# Air Quality Modeling Technical Support Document: NJ 126 Petition of September 17, 2010

U.S. Environmental Protection Agency  
Office of Air Quality Planning and Standards  
Air Quality Assessment Division  
Research Triangle Park, NC 27711

## I. Introduction

Figure 1. AERMOD predictions of the 4th high daily maximum 1-hour concentrations (99<sup>th</sup> percentile) based on allowable emissions.

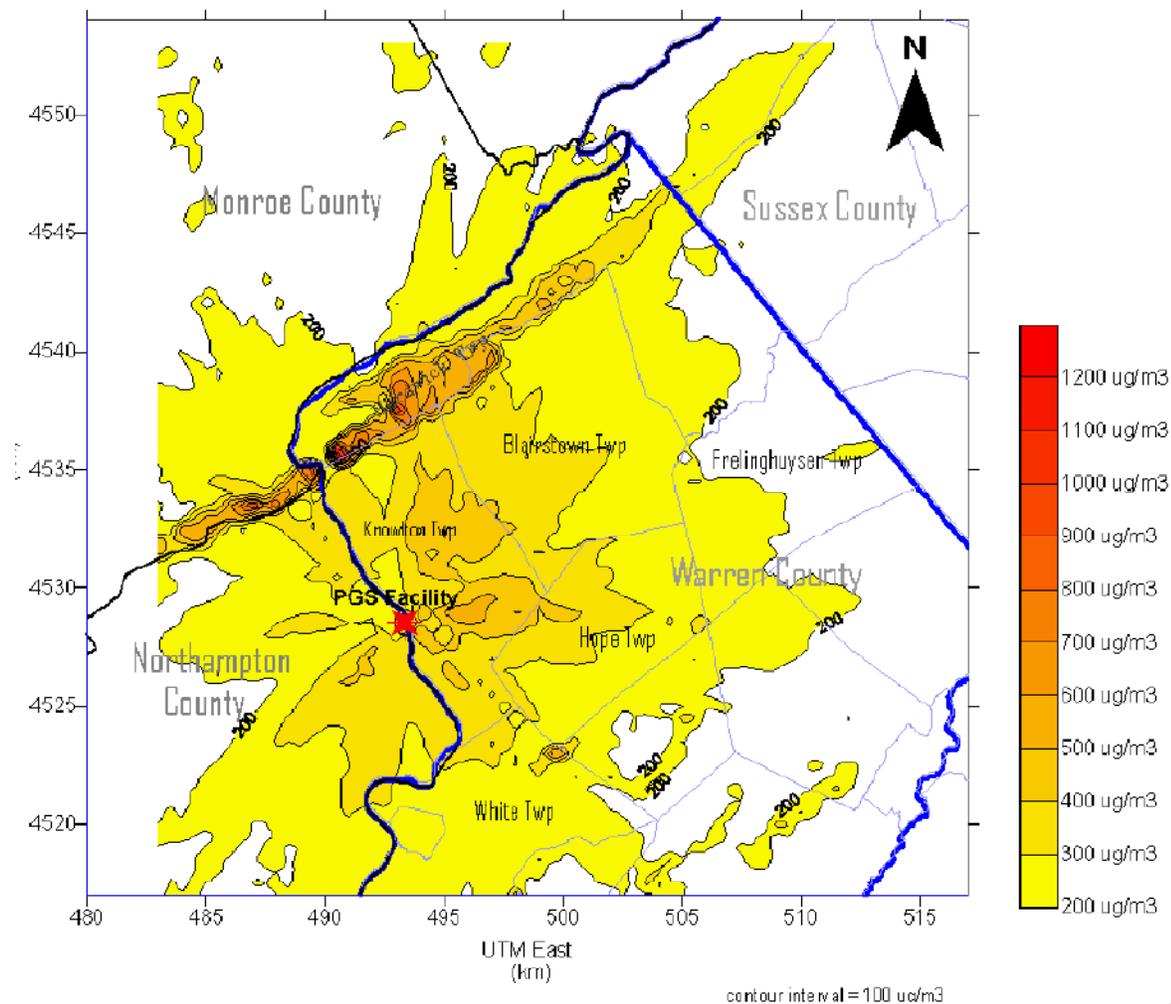
Figure 1 (based on Figure 3 from NJDEP exhibit 2) shows the AERMOD predictions of the 4th high daily maximum 1-hour concentrations (99<sup>th</sup> percentile) based on allowable emissions. The maximum concentration of 1,402 µg/m<sup>3</sup> is located on the Kittatinny Ridge on the NJ side of the Delaware Water Gap, about 7 km northwest of the Portland Plant.

Figure 2. CALPUFF predictions of the 4th high maximum daily 1-hour. concentrations (99<sup>th</sup> percentile) based on allowable emissions.

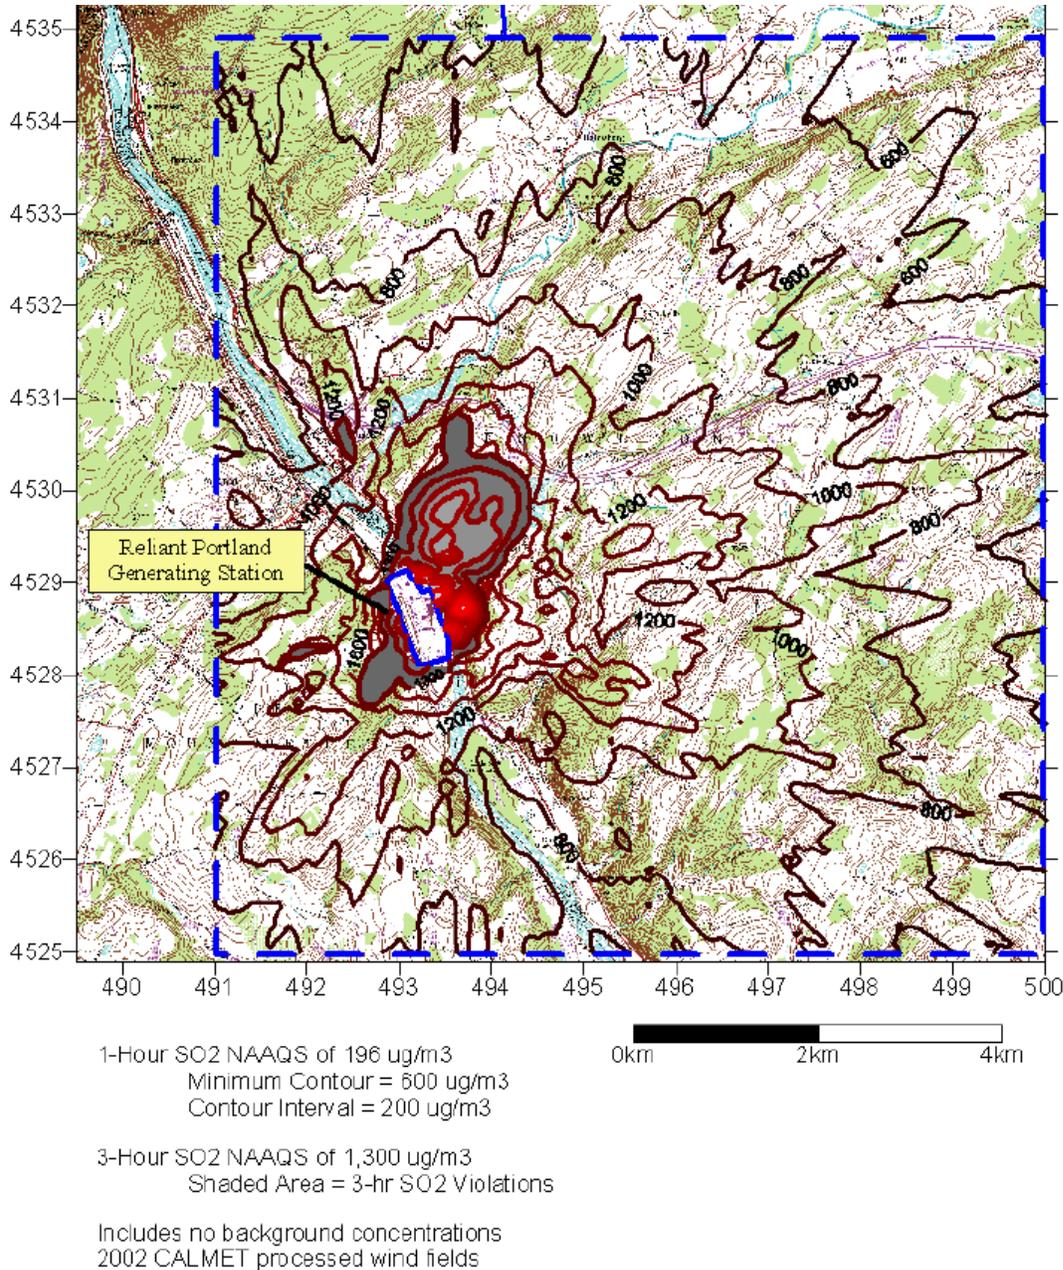
Figure 2 (based on Figure 1 from NJDEP Exhibit 3) shows the CALPUFF predictions of the 4th high daily maximum 1 hour. concentrations (99<sup>th</sup> percentile) based on allowable emissions. A review of modeling files submitted by NJDEP indicates that the maximum concentration of 3,455  $\mu\text{g}/\text{m}^3$  is located within about 100 meters of the Portland Plant at an elevation of 3 meters above stack base on the PA side of the Delaware River.

We also note that the spatial distribution of 1-hour SO<sub>2</sub> impacts predicted by CALPUFF (in the petition application) is very different than the impacts predicted by AERMOD. The CALPUFF modeling shows extremely high 1-hour SO<sub>2</sub> concentrations very close to the Portland Plant (see Figures 1, 2, and 3 of Exhibit 3). The highest impacts based on the 2002 CALPUFF modeling with allowable emissions of 3,455 µg/m<sup>3</sup> (99th percentile of daily maximum 1-hour values) occurs about 100 meters from units 1 and 2 at an elevation of only 3 meters above the stack base in Pennsylvania. These results are physically unrealistic for buoyant plumes from tall stacks such as units 1 and 2 at the Portland Plant, raising additional concerns regarding the appropriateness of CALPUFF for this application.

Figure 3. Location of Portland Meteorological Tower<sup>8</sup>

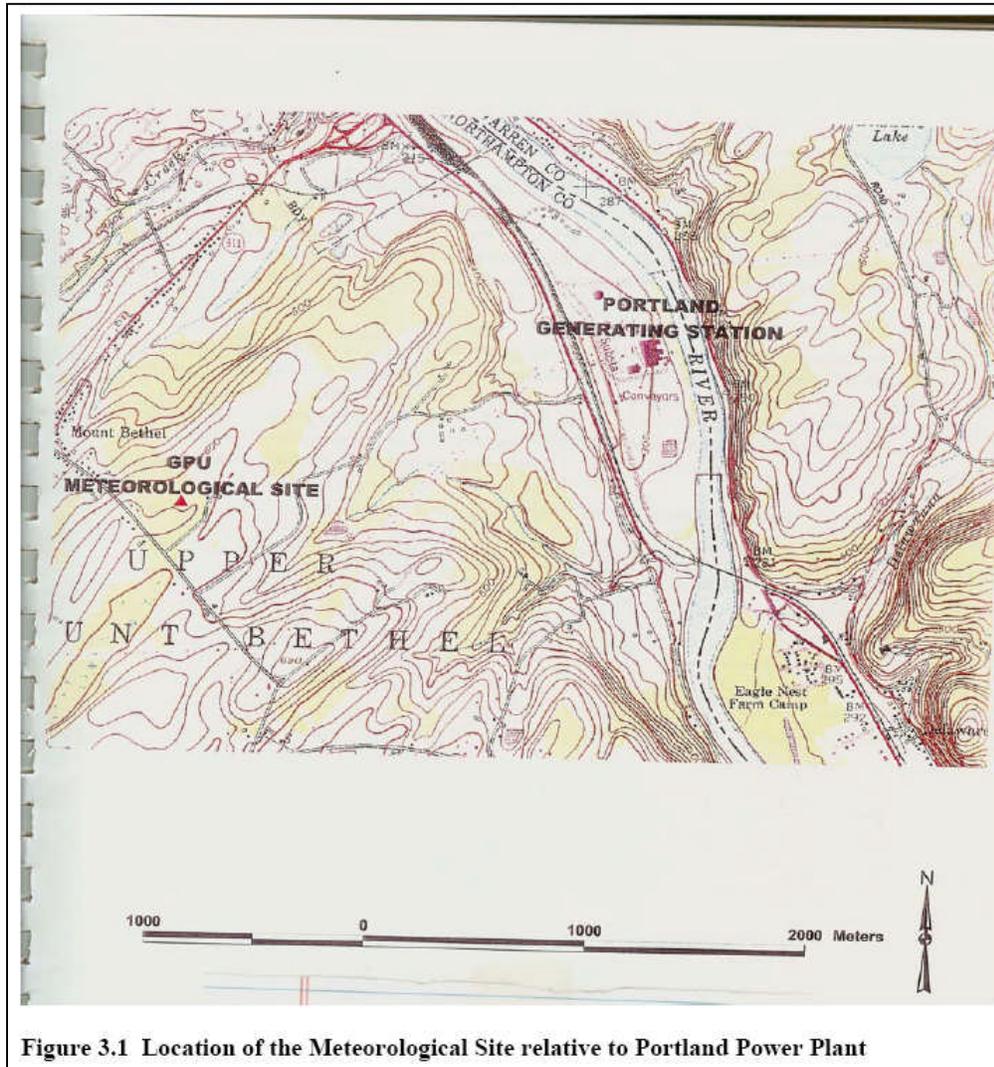
Section 8.3 of Appendix W provides guidance regarding meteorological data for use in dispersion modeling to demonstrate compliance with the NAAQS. A key issue related to meteorological data is the representativeness of the data for the particular application, including spatial and temporal representativeness. Based on a review of the data, we believe that the Portland Plant meteorological data from 1993-94 meets the basic criteria for representativeness under Section 8.3.3 of Appendix W, and therefore can be considered as site-specific data for purposes of modeling impacts from the elevated stacks for PGS units 1 and 2. The 1993-94 data also meets the minimum criterion for length of meteorological data record of at least one year of site-specific meteorological data recommended in Section 8.3.1.2 of Appendix W, and it is the most representative meteorological data available to support refined dispersion modeling for the Portland Plant. However, the difference of about 100 meters in the base elevation for the meteorological tower vs. the stack base elevation (see Figure 3) raises concerns regarding how the meteorological data were input to the AERMOD model in the NJDEP modeling analysis, especially given that the stack heights for units 1 and 2 are about 122 meters and that plume heights of concern for units 1 and 2 are about 200 to 400 meters above stack base. The AERMOD modeling submitted by NJDEP used the measurement heights above local ground at the tower location for the meteorological data input to the model, effectively assuming that the measured profiles of wind, temperature and turbulence are "terrain-following."

Without adjusting for the difference in base elevation of about 100m between the meteorological data and the stacks, wind speeds are likely to be biased high and the wind directions may not be representative of plume heights. Table 1 of NJDEP's analysis of complex winds in the region surrounding the Portland Plant, submitted as Exhibit 11 to NJDEP's May 12, 2010 petition, is shown below as Table 3 and provides an example that illustrates this point, where wind direction varies with height indicating a transition from westerly flow below about 210 meters above ground to northwesterly flow between 210 and 270 meters, and then to northeasterly flow at 300 meters and above for hour 11 on July 18, 1993. A similar pattern occurs for hour 12 on the same day, but the transitions occur at somewhat lower heights above ground. Accounting for the differences in base elevation between the meteorological tower and Portland Plant stacks, this transition in wind directions occurs within the range of plume heights of concern for Units 1 and 2.

Based on the concerns documented above, we have concluded that some adjustments to the measurement heights for the Portland Plant site-specific meteorological data are appropriate in order to address these issues of representativeness for this application. However, since the maximum design value concentration in the NJDEP AERMOD modeling analysis was nearly seven times the NAAQS, we do not expect these issues regarding the meteorological data to change the overall conclusion that the Portland Plant emissions are likely to significantly contribute to nonattainment or interfere with maintenance of the 1-hour SO<sub>2</sub>. Adjustments to the meteorological data that may play an important role in determining the remedy are discussed below in Section III, with more details provided in Appendix B to this TSD.

Figure A.1. Distribution of highest ranked 3-hour network-wide concentrations from Martins Creek validation study (based on Figure C.1 of Exhibit 12).

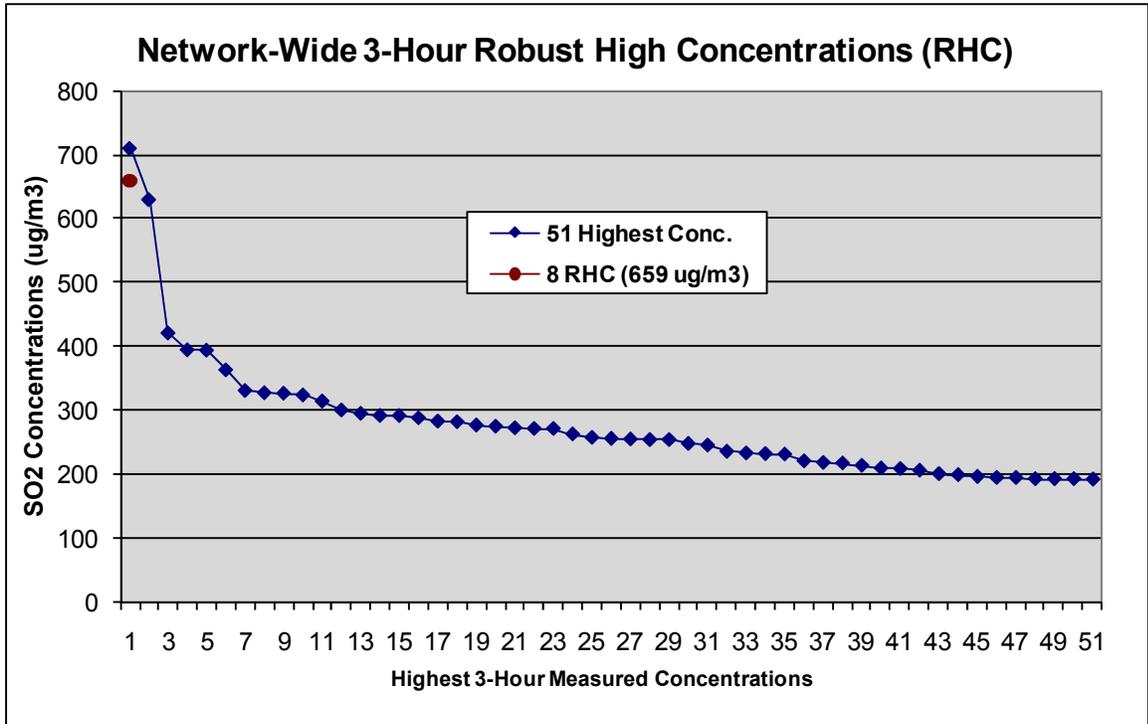
The highly variable number of samples selected to compute RHCs in the NJDEP validation report represents a significant departure from standard practice, without any clear technical basis, and raises serious concerns regarding the conclusions of NJDEP’s validation of CALPUFF. For example, Figures C.1 and C.2 of the NJDEP validation report (shown below as Figures A.1 and A.2) show the ranked distribution of network-wide 3-hour and 24-hour observed concentrations, respectively, where  $N=8$  was selected for the 3-hour RHC and  $N=26$  was selected for the 24-hour RHC. The overall shape of these two distributions appears to be fairly similar and there is no clear justification for such different choices in the number of samples in these two cases.

To illustrate the potential importance of this issue to the model evaluation results, Table A.1 compares modeled-to-monitored RHCs for the network-wide 3-hour and 24-hour averages based on different values of  $N$ . The rows corresponding to the values used by NJDEP are shaded. We note that the shaded values are the “best” ratios for each averaging period for CALPUFF (i.e., closest to 1.0), but the “worst” ratios for each averaging period for AERMOD (i.e., furthest from 1.0). For every other case, the AERMOD ratios are closer to 1.0 than the corresponding CALPUFF ratios. The AERMOD ratios also show less variation across the range of values for  $N$  than the CALPUFF results. These comparisons of RHCs based on different values of  $N$  call into question the methods and conclusions of the NJDEP validation study regarding the relative performance of the CALPUFF and AERMOD models on this field study database. However, we also point out that overall these model performance results do not suggest significant differences in performance for CALPUFF vs. AERMOD.

Figure A.3. Q-Q plots of CALPUFF and AERMOD predicted concentrations and observed concentrations (from Figure 9 of NJDEP’s CALPUFF validation report, Exhibit 12 to the May 12, 2010 NJDEP petition).

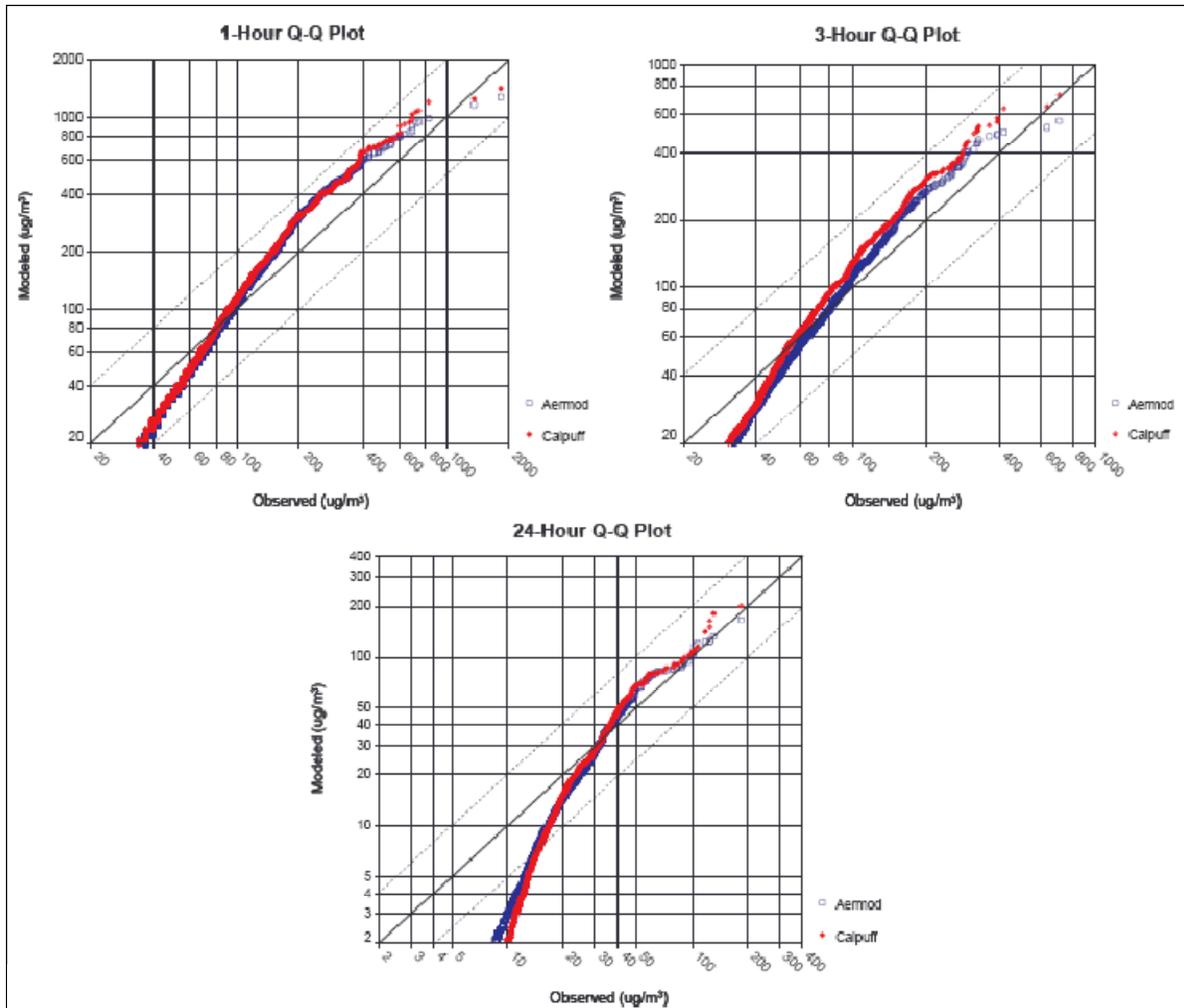
The Q-Q plots included in the NJDEP validation report (shown below as Figure A.3) also provide a clear visual representation of model performance based on the same data used to calculate the network-wide RHC values. These Q-Q plots appear to corroborate the conclusion that the performance of the CALPUFF and AERMOD models on this database is similar, but that AERMOD shows slightly better overall agreement with observations.

Figure A.5. Residual box plots for CALPUFF and AERMOD based on predicted/observed ratios paired by rank (from Figure 9 of NJDEP's CALPUFF validation report).

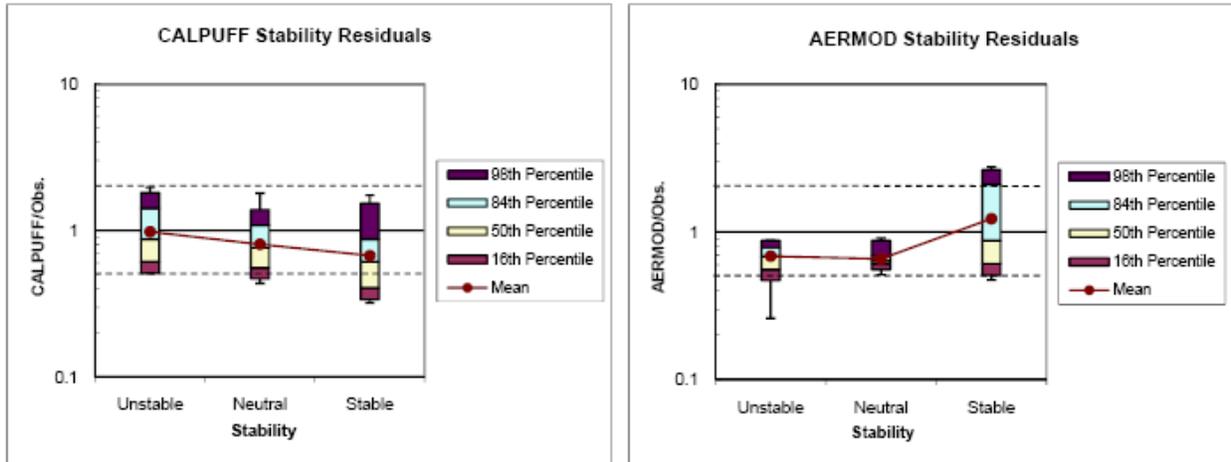
The NJDEP CALPUFF validation report describes the residual box plots included in that study as representing “a method of directly comparing modeled and monitored data.” It further states that “[t]hey are generated by calculating the ratio of each model’s **ranked** maximum prediction at any of the eight monitors for an hour to the **ranked** maximum measured 1-hour concentration at any of the eight monitors” (emphasis added). The independent variable used to group the results in the NJDEP study was stability, based on the three categories of unstable, neutral, and stable. The use of modeled vs. monitored concentrations paired by rank (similar to the data used in the RHC calculation or Q-Q plots) is not consistent with the intent of residual plots, which should be based on the distribution of predicted/observed ratios paired in time. The Q-Q plots and RHC comparisons are intended to compare results paired by rank as part of the operational component of the evaluation. However, those comparisons by rank are focused on the upper end of the ranked distribution since that is the only part of the distribution that is relevant from an operational perspective. A comparison of modeled and monitored results paired by rank for the lower portion of the distribution has no relevance to evaluating a model’s performance. Therefore, the residual plots provided in Figure 9 of the NJDEP validation report (shown below as Figure A.5) provide no useful information on the relative performance of the CALPUFF and AERMOD models on this database.

Figure A.6. Residual box plots for CALPUFF and AERMOD based on predicted/observed ratios paired in time.

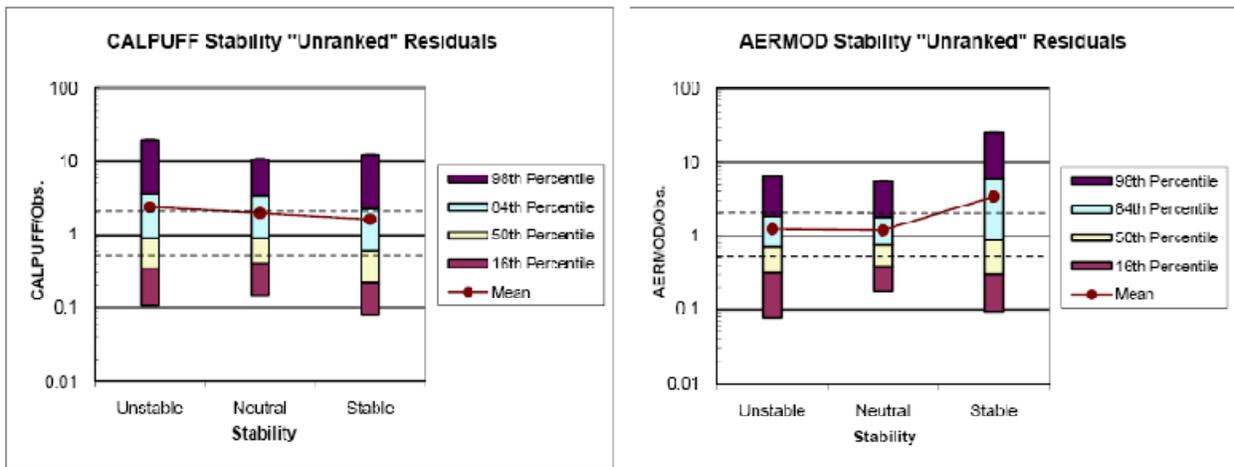
Based on data provided by NJDEP, we generated residual box plots using the appropriate temporal pairing of modeled and monitored concentrations to assess what impact this would have on the comparison. The original results presented in Figure A.5 suggest a bias for AERMOD to underpredict concentrations during unstable and neutral conditions, with better performance for stable conditions. The CALPUFF results show unbiased performance for unstable conditions, with a trend toward under predicting for neutral and stable conditions, but the distribution crosses the ratio of 1 for all stability categories. The residual box plots based on predicted/observed ratios paired in time are shown in Figure A.6. These results show nearly unbiased results for AERMOD for unstable and neutral conditions, with some bias to overpredict for stable conditions (although the median ratio for stable is close to 1). The CALPUFF results in Figure A.6 show some tendency to overpredict for all stabilities base on the mean values, although the median values are much closer to 1 than the mean values for unstable and neutral conditions. It should also be noted that the vertical scale in Figure A.6 is much broader than Figure A.5, since the ratios paired in time exhibit a greater degree in variability than results paired by rank, as would be expected. Figure A.7 shows the original NJDEP data paired by rank as plotted in Figure A.5 using the same vertical scale as Figure A.6 for comparison purposes.

Figure B.7. Adjusted and unadjusted wind speed profiles for the Portland Plant compared to Martins Creek site-specific meteorological data.

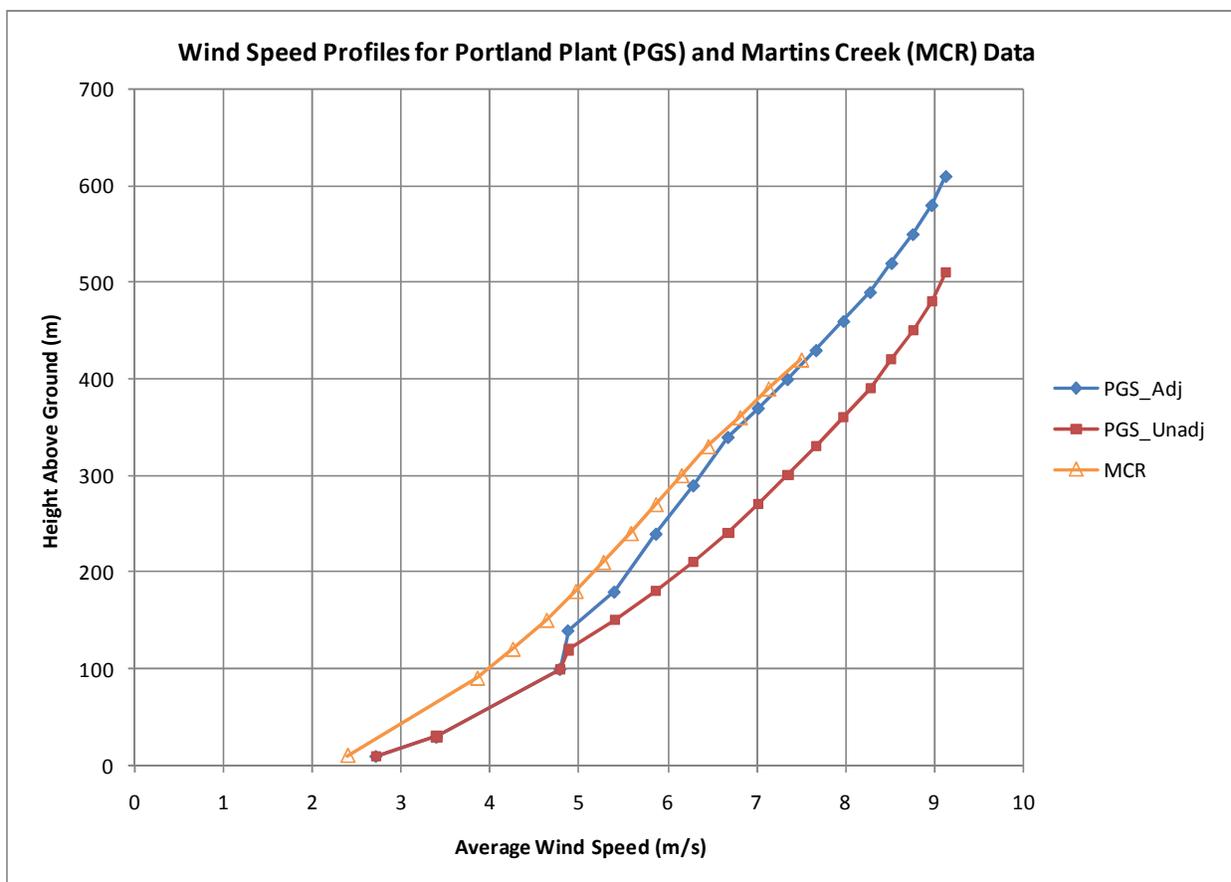
between average speeds for the higher levels at Martins Creek and Portland after the height adjustment. We believe that these comparisons confirm our concern regarding this representativeness issue and also support our proposed adjustments to the measurement heights for the Portland meteorological data to address that concern. We also expect that the proposed adjustments in measurement heights will improve the representativeness of wind directions at plume level for units 1 and 2.
